Pre-Preliminary Plan No. 720110090, Halpine View

description

- The Applicant is requesting Planning Board advice and feedback for a potential rezoning from R-30 to PD-60 (Urban High – Density Category) on the Subject Property;
- This request is for advice/discussion only and there are no formal or binding decisions that have to be made;
- Northeast quadrant of the intersection of Twinbrook Parkway and Halpine Road;
- R-30 Zone, 1992 Approved and Adopted North Bethesda/Garrett Park (NBGP) Master Plan, on approximately 41 acres (Gross Lot Area), 37 acres (Net Lot Area);
- Current use is 564 garden apartments;
- Applicant – Halpine Park LLC – Judy Glassie;
- Filing date: 6/2/2011.

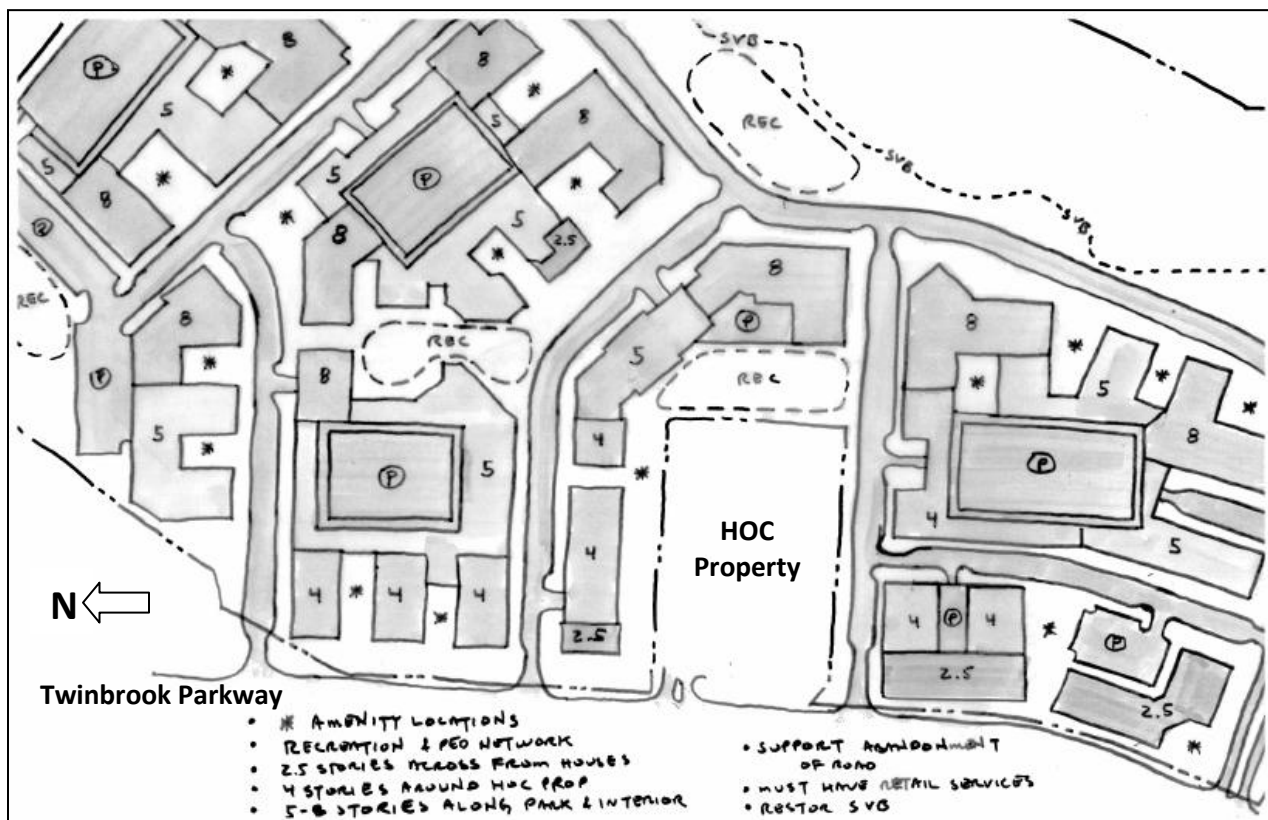
Primary environmental concerns include managing stormwater runoff from the site and restoring the damaged tributary channel. Development must be pulled out of the stream buffer, and unforested areas of the stream buffer should be planted. Invasive plants will present a challenge, and will need to be managed during the forest planting maintenance period. Restoration of this stream and stream buffer will become more important as the County faces TMDL (Total Maximum Daily Load) limitations for sediment and nutrients in the near future.

1. Applicant will be required to remove existing structures from the stream buffer and restore the buffer through reforestation.
2. Applicant should coordinate with the adjacent Parklawn North development on stream restoration for the tributary of Rock Creek crossing the western portion of the Halpine View property. Existing stream erosion has exposed sewer infrastructure, and is generating sediment loads that carry into Rock Creek. Parklawn North has a requirement for stream restoration in this tributary when Lot 5 redevelops.
